Office Action Summary	Application No. 10/594,312	Applicant(s) YOKOI, TADASHI
	Examiner RYAN ELLIS	Art Unit 3745

DETAILED ACTION

fig.4

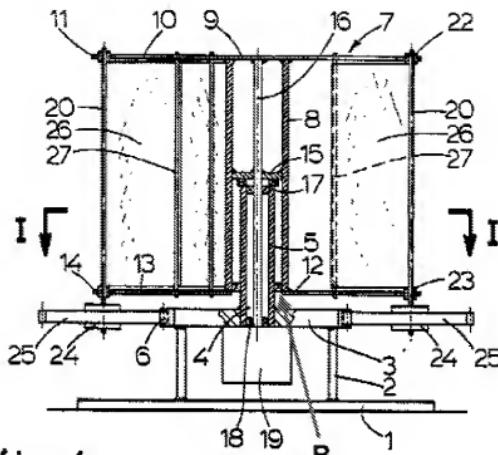
A cantilever type vertical axis wind turbine featured by comprising an outer race side rotor (hub 8) having a plurality of blades (vanes 26) for producing a rotational torque with wind, an inner race side stationary column (support member 5) having one free end externally unconstrained and the other stationary and, a plurality of bearings (17 and B, see Figure 4 as reproduced and annotated by the examiner below) mounted between said outer race side rotor and said inner race side stationary column for supporting said outer race side rotor on said inner race side stationary column, and a torque transmission shaft (16) of a cylindrical column or hollow cylindrical shape whose lower end portion having a function of an output shaft terminal of the wind turbine and passes through the inside of said inner race side stationary column in the direction from the free end to the stationary end, wherein the position of said outer race side rotor, which is face to or adjacent to said free end of the stationary column, is the output end for said rotational torque, and said torque transmission shaft is connected to said output end.

(support member 5) having one free end externally unconstrained and the other stationary and, a plurality of bearings (17 and B, see Figure 4 as reproduced and annotated by the examiner above) mounted between said outer race side rotor and said inner race side stationary column for supporting said outer race side rotor on said inner race side stationary column, and a torque transmission shaft (16) of a cylindrical column or hollow cylindrical shape having a function of an output shaft terminal of the wind turbine and passes through the inside of said inner race side stationary column in the direction from the free end to the stationary end, wherein the position of said outer race side rotor, which is face to or adjacent to said free end of the stationary column, is the output end for said rotational torque, and said torque transmission shaft is connected to the output end and at least one bearing (B) disposed on the lower side under said wind pressure center position.
